## Pedestrian & Bike Improvements Business 51 Crosswalks

**Recommendation:** Add crosswalks per the following diagrams, and add sidewalk ramps per Figures 7-10 & 7-11 on last page:

Business 51 and Moreland Ave.

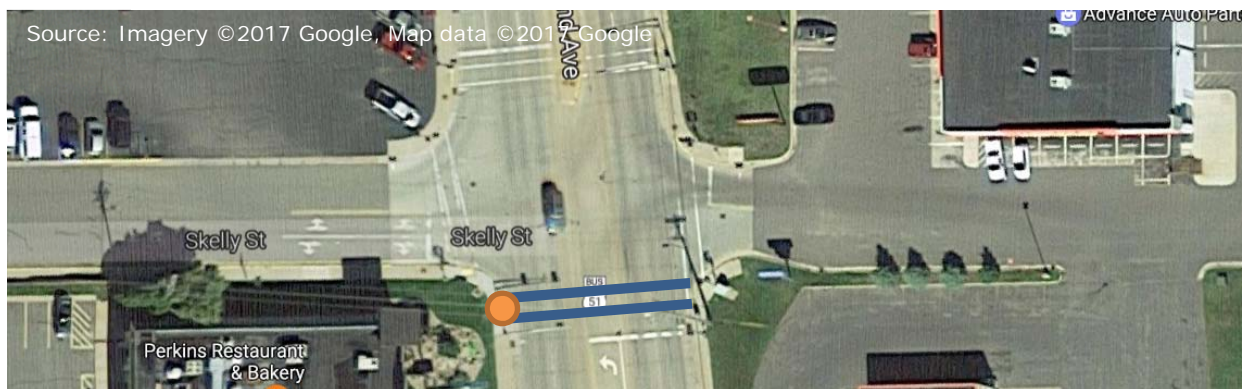
Below: The north side of this intersection provides a cross-hatched mid-street waiting area to more safely cross 4-lanes.

Business 51 and Robb St.

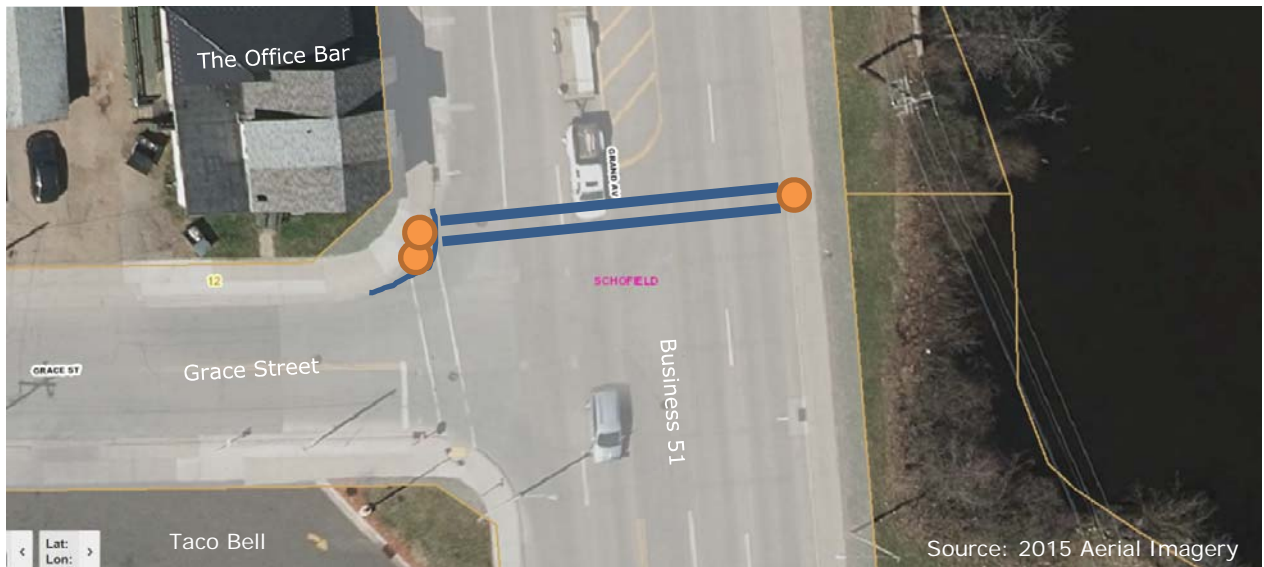
Below: The north side of this intersection provides a cross-hatched mid-street waiting area to more safely cross 4-lanes.

Business 51 and Radtke St, looking south.

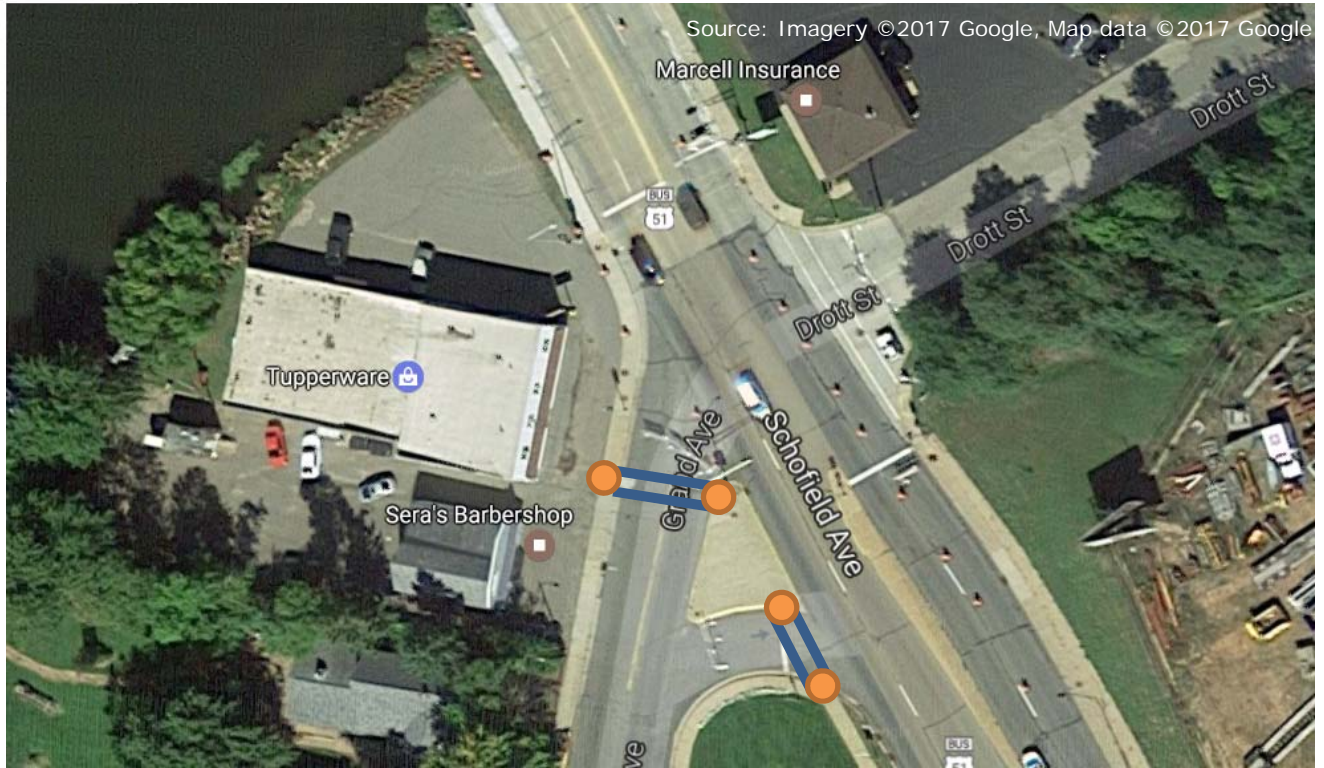
Below: Every traffic light intersection should have crosswalks on all 4 sides.

Crossing of Grand Ave at Business 51.

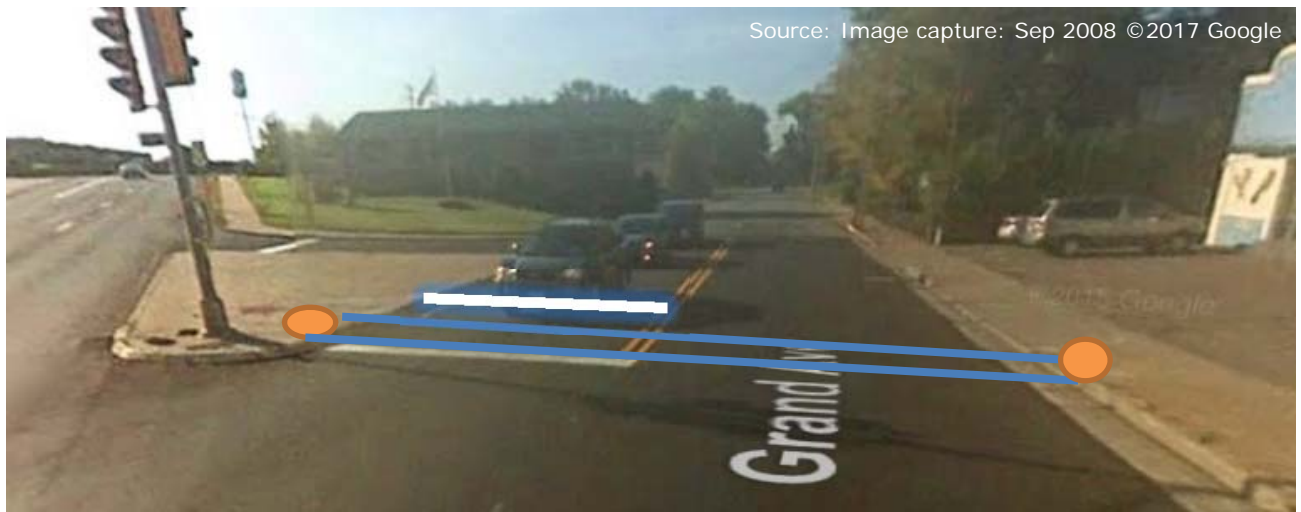
Below: Every traffic light intersection should have crosswalks on all 4 sides, and somehow the right-turn lane is missing a crosswalk too.

Below: Northbound stop line on Grand Ave would need to move south to accommodate new crosswalk.

**Note:** Find in-pavement vehicle detector.

Figure 7-10. At intersections with narrow sidewalks and wide turning radii, two parallel curb ramps should be considered.

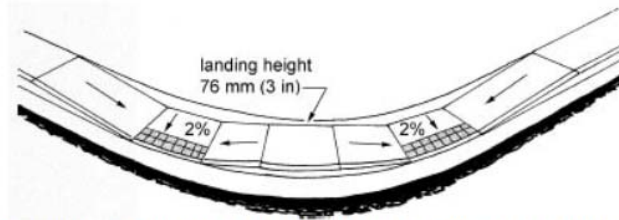
Below: Since bicycling is now allowed on the sidewalks next to Business 51, then any new ramps in the sidewalks should be designed like Figure 7-10 and 7-11 below. Key design point is to lower the whole sidewalk, and then install truncated domes in the area of the level sidewalk that is closest to Business 51.
